State of California
Environmental Protection Agency

AIR RESOURCES BOARD

**PUBLIC HEARING TO CONSIDER THE ADOPTION OF EXHAUST
AND EVAPORATIVE EMISSION CONTROL REQUIREMENTS FOR
SMALL OFF-ROAD EQUIPMENT AND ENGINES LESS THAN OR
EQUAL TO 19 KILOWATTS**

“REVISED” FINAL STATEMENT OF REASONS

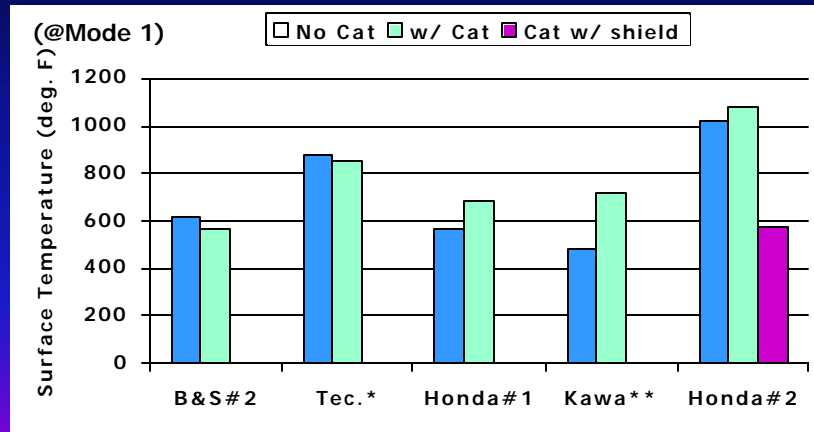
19. Comment: The use of high efficiency catalyst systems raise many concerns, such as the extreme temperatures, oil carryover rates, limited space available for the converter, and the physical location of the converter relative to the engine all contribute to make durability a significant technical challenge for small engine applications. The heat associated with the use of high efficiency catalysts and the "packaging issues" associated with installing engines and catalysts in equipment, especially where that equipment has unique design constraints related to its functionality, lead to substantial concerns regarding potential fire safety issues. Engine and equipment manufacturers will not produce an unsafe product. As such, engine and equipment manufacturers, by necessity, will have to do whatever is required to assure that their products are safe and do not pose any potential fire

Comment: The Staff Report does not present all the safety data and information presented by numerous experts at the July 2, 2003 ARB public workshop in Sacramento, as well as recent letters from various fire and safety organizations which document technical reasons why ARB must relax the exhaust standards in its August 8th Regulatory Proposal. In fact, the eight hours of testimony at the July 2nd workshop provides a more accurate and complete administrative record (particularly on catalyst-related heat and safety issues) than the relatively short and incomplete summary of issues presented in the Staff Report. First, the Staff Report could be misinterpreted as implying the ARB/SwRI test program showed only a relatively modest temperature rise in the tested catalytic exhaust systems. However, at the July 2nd workshop, manufacturers suggested (through thermal imaging) that SwRI did not test the hottest areas around the catalyst, which generate the most significant heat. Unfortunately, SwRI only measured the much cooler air at a different part of the exhaust stream. This undermines the credibility of SwRI's heat testing and related conclusions.

Second, in the Staff Report, ARB cites to only "one set" of flawed test results from the SwRI study which did not show a significant temperature rise on that one catalyzed engine. However, at the July 2nd workshop, manufacturers documented that even ARB's understated heat measurements showed temperature rises of over 350°F for several tested catalyzed exhaust systems.

Oxidation of HC and carbon monoxide (CO) is an exothermic reaction, and the heat it generates, along with any enrichment of the air-fuel ratio to further reduce engine out emissions could lead to increased exhaust gas temperatures and catalyst/muffler skin temperatures. Manufacturers have raised concerns over safety due to a potential for increased heat generation from the use of a catalytic converter, which could occur if additional mitigation measures are not performed. Manufacturers have noted potential for operator injury from burning, turf browning after engine shutoff in lawn care applications, fire during refueling, and melting of fuel tanks and other plastics incorporated in the equipment. While the American National Standards Institute (ANSI) temperature guidelines vary, OPEI has specifically indicated to staff that individual manufacturers frequently prefer to adhere to heat exposure temperature limits in the range of 150 degrees Fahrenheit. A study conducted by the San Dimas Technology and Development Center, which is a unit of the United State Department of Agriculture Forest Service, indicates that grass

clippings can ignite if they come into contact with surfaces above 518 degrees Fahrenheit.

In response to issues concerning the potential for high exhaust temperatures, the ARB sponsored testing at SwRI included many temperature readings of both current engine designs and the catalyst equipped prototype designs. SwRI engineers used good engineering principles in determining where to place the thermocouples to appropriately measure muffler/catalytic converter skin and exhaust temperatures. Testing at SwRI indicated existing muffler skin temperatures already reached levels in excess of 500 degrees Fahrenheit for walk behind mowers. Currently, manufacturers use muffler heat shields to prevent contact with the muffler. Thus, in response to the commenter's concerns, there are no technological barriers, which would prevent manufacturers from using similar shielding for engines with mufflers containing catalysts. As part of the SwRI test program, the catalyst system equipped engines were tested for their full useful life to ensure that the engines and catalyst systems would maintain emissions for the life of the engines, would be durable, and remain within the manufacturer specifications. The testing showed that the catalyst systems generally met these requirements.

The above figure shows that in some cases, the addition of the catalyst did result in slightly increased muffler surface temperatures. Note that for the Briggs engine (“B&S #2”) and the Tecumseh engine, it would appear that the muffler surface temperature actually decreased with the addition of the catalyst. While this is possible depending on how the engine was adjusted prior to testing, staff believes it is more likely due to test variability. It should also be noted that the catalyst efficiencies observed in the SwRI test program are much higher than those expected to be required to meet the adopted emission standards. Specifically, in the SwRI program, catalyst efficiencies were shown to be as high as 70 percent. The catalysts used by manufacturers to meet the adopted standards would likely have efficiencies on the order of 35 percent. This difference is significant because if the required catalyst efficiency is decreased, the exothermic reaction correspondingly decreases which in turn results in a much smaller increase in exhaust temperatures. Staff contends that this should eliminate any significant safety concerns raised by industry. This was confirmed by Honda in its testimony to the Board in September 2003 in support of staff’s proposal. In part, Honda testified that “We think that the modified exhaust emissions proposal presented today of 10 and 8 grams will make it possible to have an exhaust system with a lower risk of being a fire safety hazard. It is manageable today on our current products. And with this revised proposal it will be manageable on the future engines. The revised proposal will also be significantly more cost-effective air quality improvement for California. This modification has been a positive and very helpful change. While there is always risk, even on today’s products, due to their diversity of use or even misuse in their application, we do not believe that the staff proposal presented here today for future exhaust emission standards will have a significant impact on the safety of our future engines in comparison to current engines or products.” Thus, while staff believes that in some cases, the increase in temperature will be small, on the order of less than 50 degrees Fahrenheit, in other cases, it may be somewhat higher. Briggs provided a presentation at the July 2, 2003 public workshop which showed a peak surface
